181795  
RES-NEW-19-00111

## Certificate of Appropriateness

**Property** 1945 N. Bartlett Ave. Milwaukee Fire Department's Firehouse Ladder Co. No. 5  
**Description of work** Convert property to single family residential use with new window openings and a rooftop addition. Substantial rehabilitation work on the interior and exterior is proposed.  
**Date issued** 6/25/2019 PTS ID 114702 COA: rehab and addition

Historic photo and proposal rendering

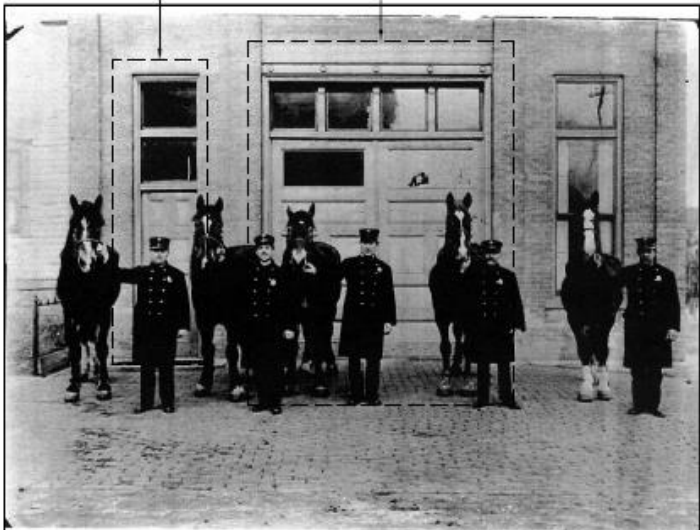
MATCH BRICK PATTERN AT PEDIMENT.

MATCH WOOD DOOR DESIGN.

MATCH WOOD DOOR, WOOD TRIM, AND LINTEL DESIGN.

MATCH MULLION PATTERN: 1x1 SASHES, TYPICAL.

1 WEST ELEVATION

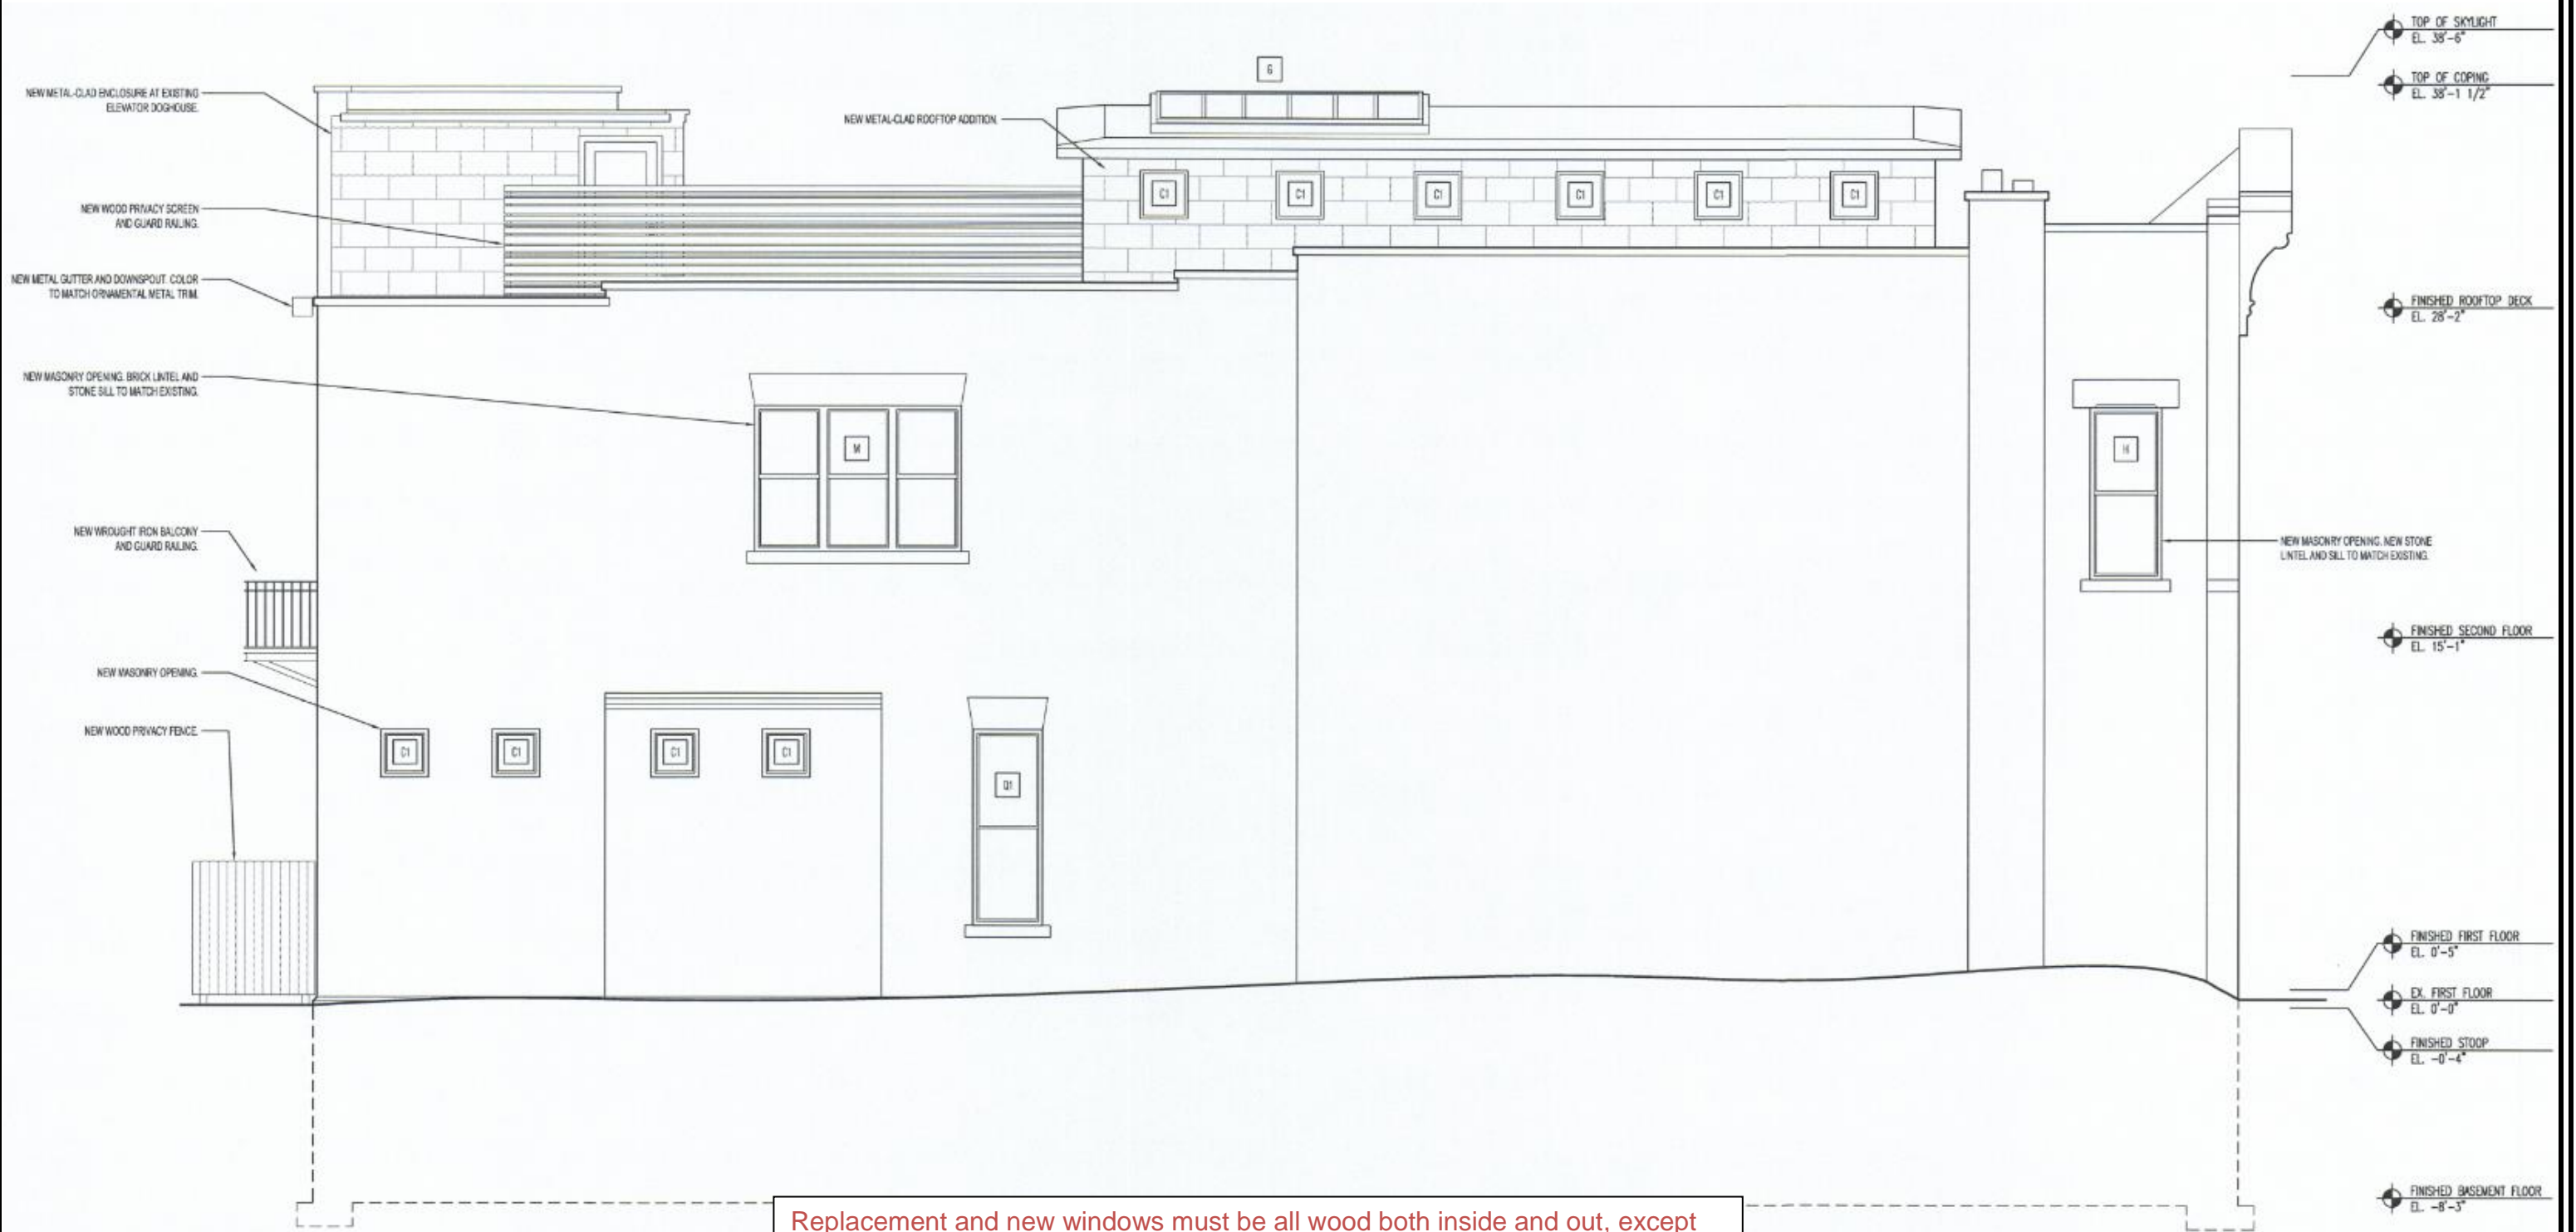
Glass block windows are not permitted on street-facing elevations. A different solution must be found. In-swing awning or hopper windows are encouraged.

2 SOUTH ELEVATION

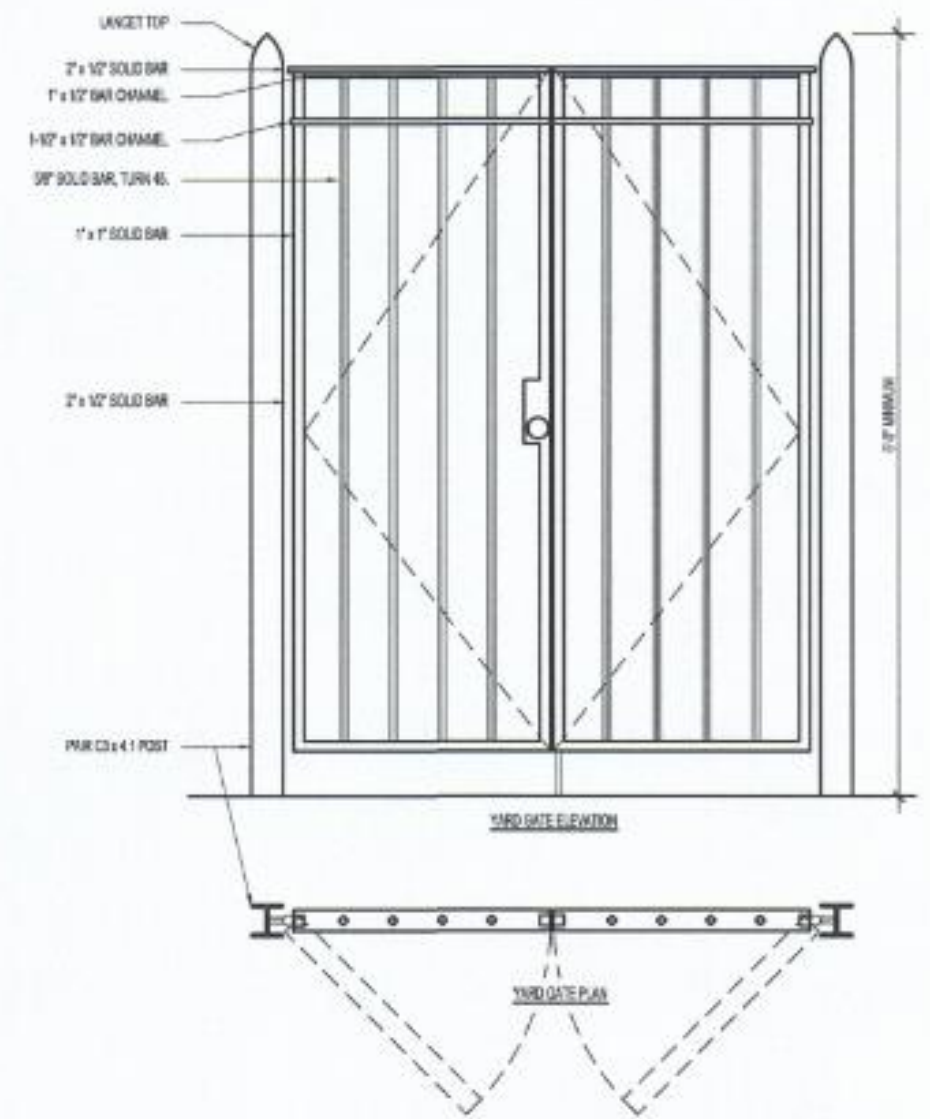
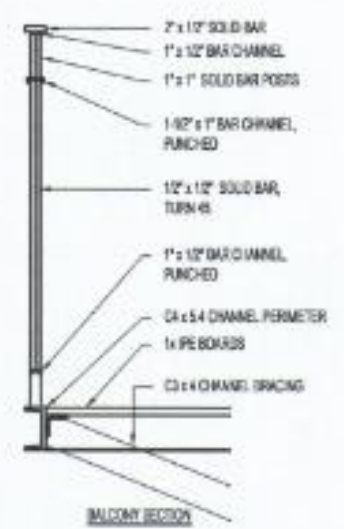
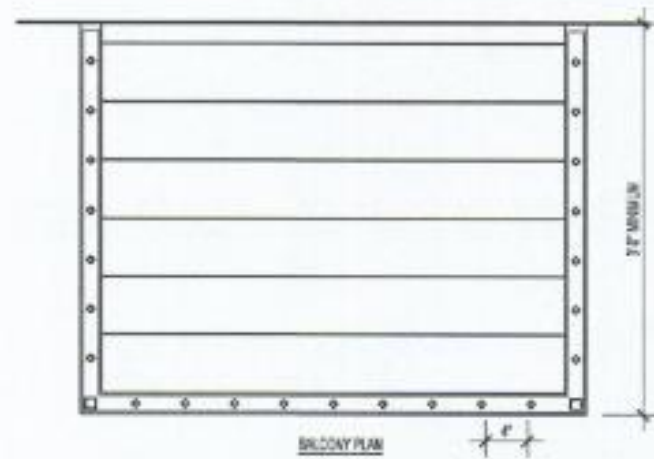
Replacement and new windows must be all wood both inside and out, except where metal-clad windows are indicated on the west end of the south elevation. No vinyl, vinyl-clad, aluminum, aluminum-clad or fiberglass windows are permitted.

1 BASEMENT WINDOWS

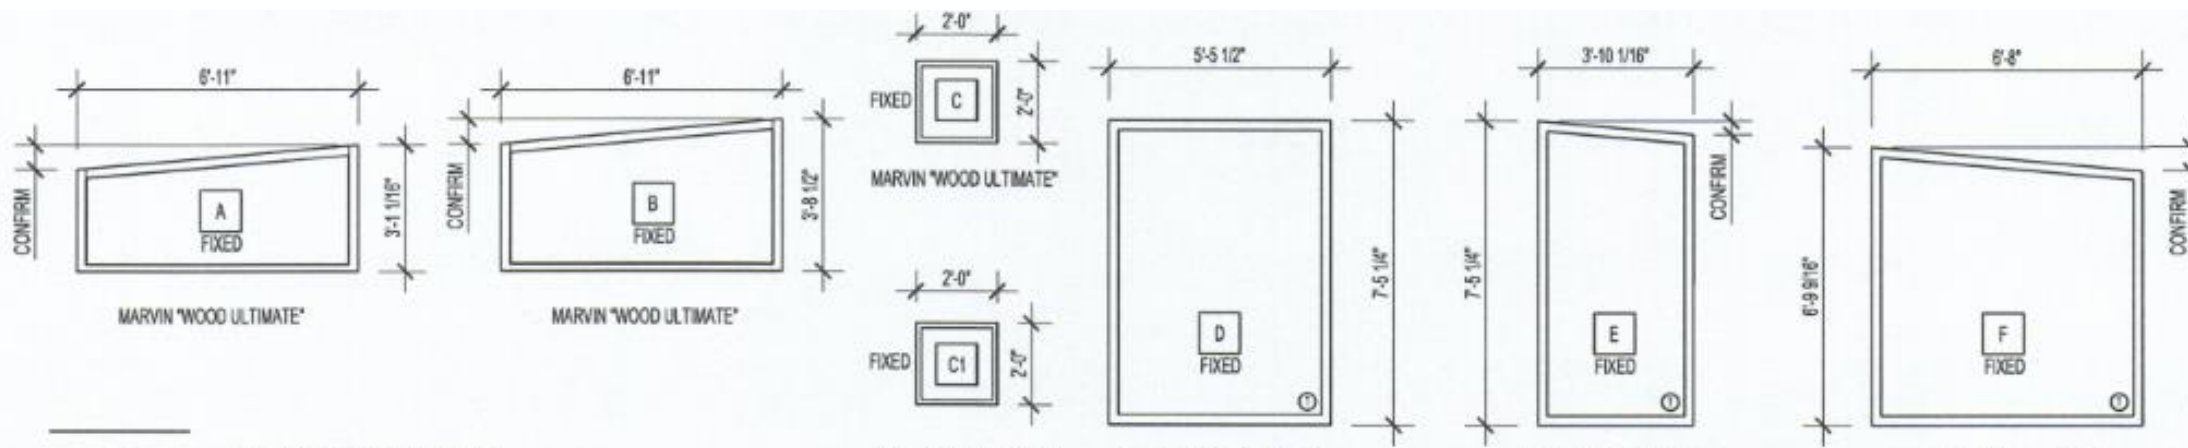
Glass block windows are not permitted on street-facing elevations. A different solution must be found. In-swing awning or hopper windows are encouraged.

1 ROOF DECK WINDOWS

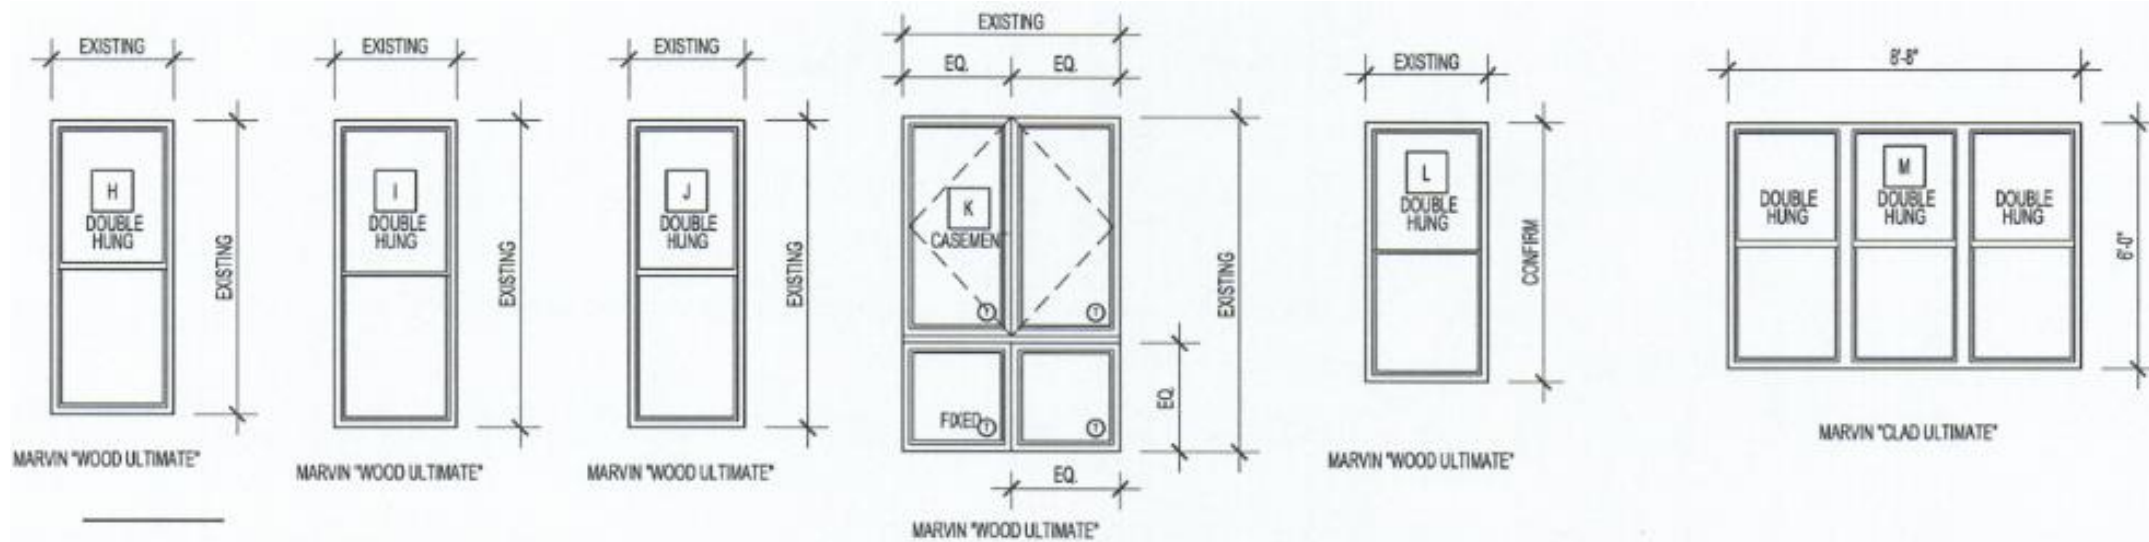
Replacement and new windows must be all wood both inside and out, except where metal-clad windows are indicated on the west end of the south elevation. No vinyl, vinyl-clad, aluminum, aluminum-clad or fiberglass windows are permitted.
